Fixing EPD and LPD in IEEE Std 802-2014

Venue: 802.1 Maintenance TG, related to IEEE Std 802-2014

This document proposes maintenance corrections in the description of EtherType Protocol Discrimination (EPD) and LLC Protocol Discrimination (LPD) in IEEE Std 802-2014.

Figure from IEEE 802.11-20-0174-01-0arc:

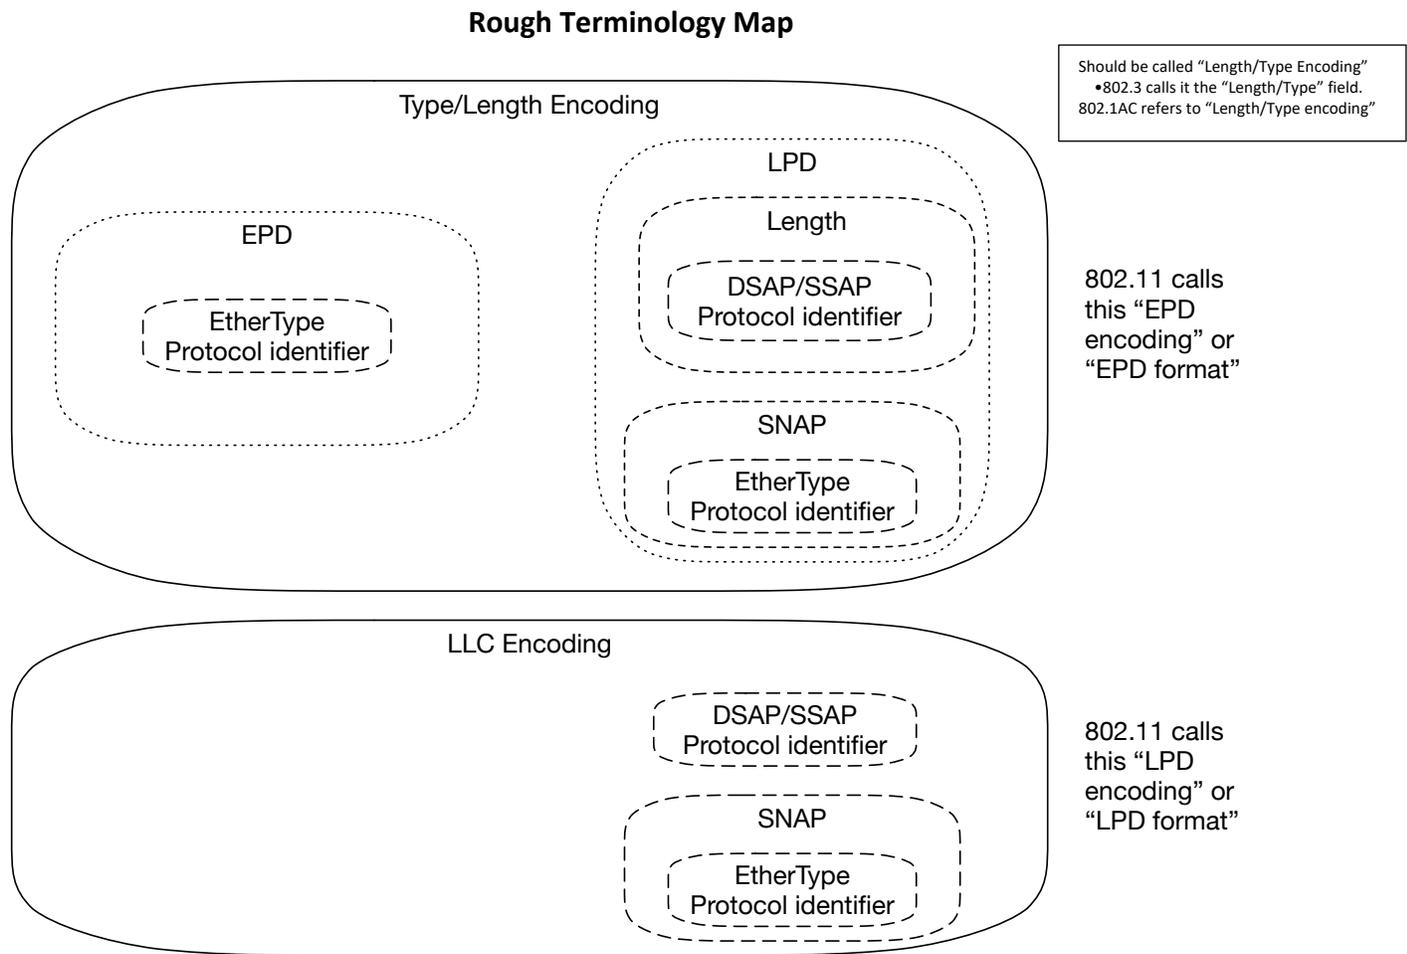
Discussed by IEEE 802.11 Architecture Standing Committee (ARC) week of 2020-01-13; inclination of some participants is to propose to rename "EPD Encoding" and "LPD Encoding" during current development of 802.11 Revision ("REVmd").

- **Clarifying EPD/LPD**
 - Reviewed: [11-20/0174r0](#)
 - Will continue to monitor 802.1's work on this
 - We may consider updates to 802.11
 - Author (Roger Marks) will work off-line based on comments, and target something for REVmd's ad hoc in Feb.
